SERVICE LETTER No. L 136-Rev.3

MODEL AFFECTED: Z 242 L aircraft, S/N: 0682, S/N 0685

SUBJECT: Aircraft manufacturer instructions for detected cracks and defects and repair instructions.

Fig. No. 1 (S/N 0682)

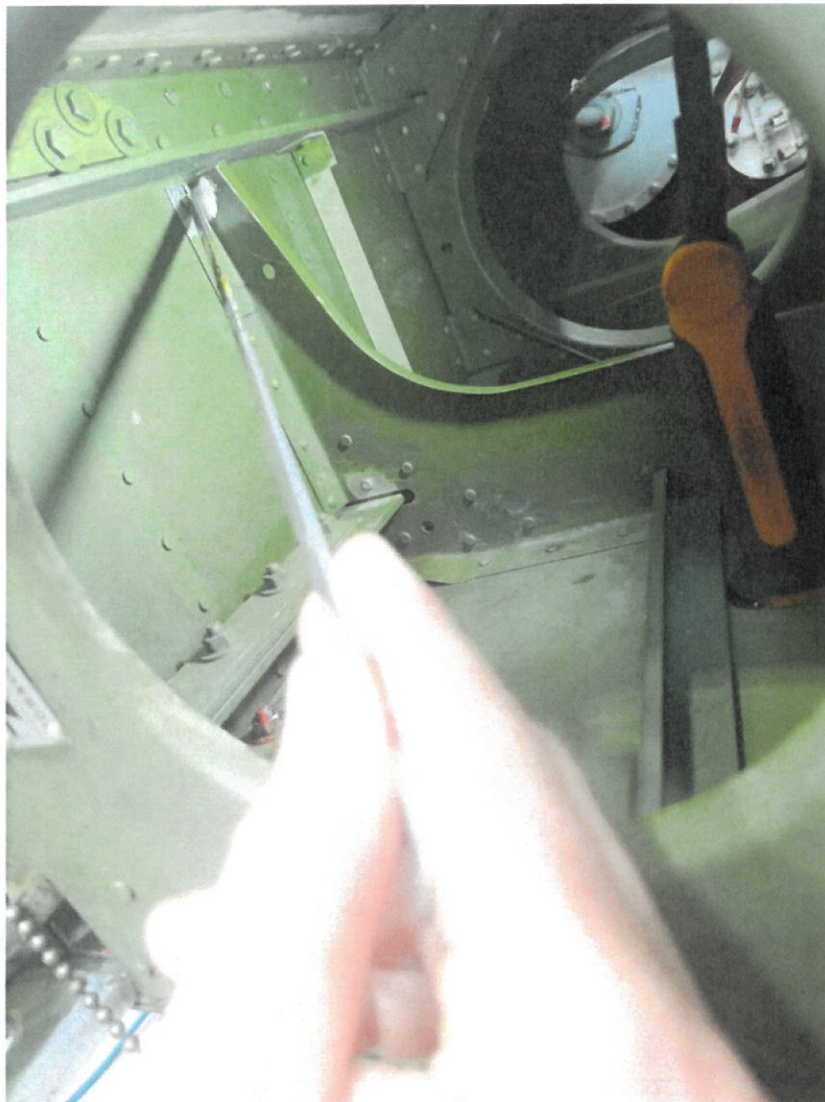
- 1) Second rib from both the left- and right-wing root. The length of the cracks is 4, resp. 2 mm (see Fig. 1 and 1A and No. 2).

1. Repair the rib cracks as described on pages 4-17 and 4-33 of the above-mentioned document. The final state of the repaired rib is as follows:

Fig. No. 4 (S/N 0682)

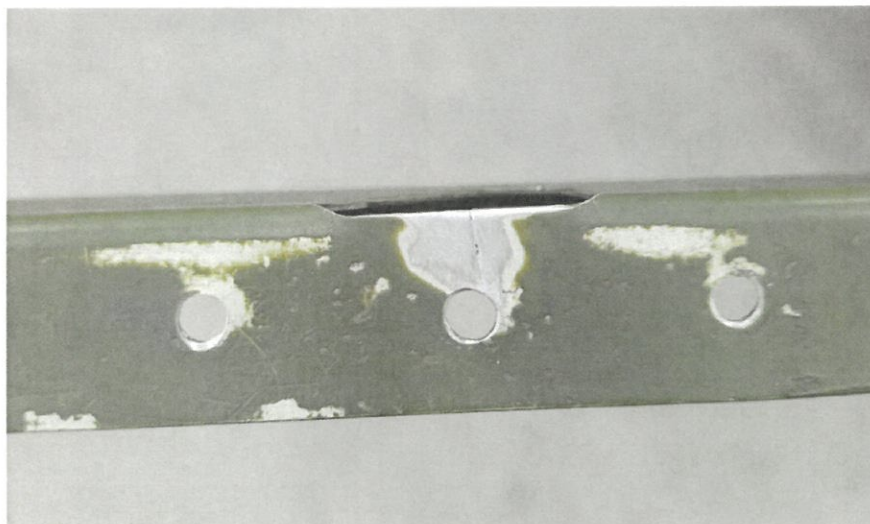
- 2) The rear part of the left root rib. The length of the crack is 3 mm (see Fig. No. 3 and No. 4.

- 2) Repair the rib cracks as described on pages 4-17, 4-30 and 4-37 of the above mentioned document. The final state of the repaired rib is as follows:

Fig. No. 5 (S/N 0682)

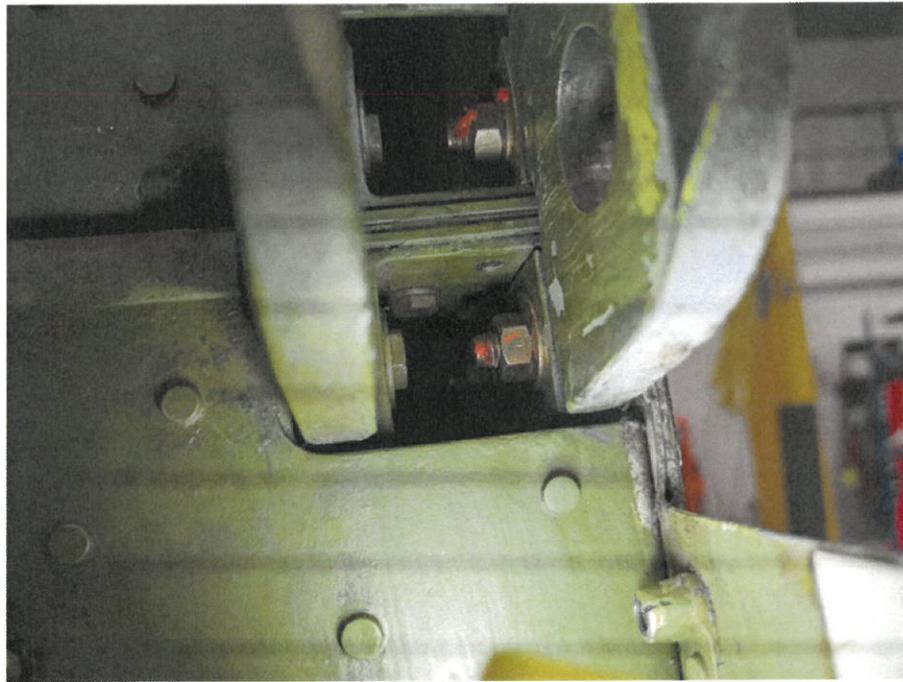
- 3) The sheared head of the technological rivet connecting the lower and upper plate of the main wing attachment point was found (see Fig. No. 5 and No. 6.).

- 3) Replace the sheared rivet by the bolt as described in Service Bulletin Z242L/20a issued by ZLIN AIRCRAFT a.s. on 6th June 1996.
The rivet replacement for the screw must be performed on both wing attachments.
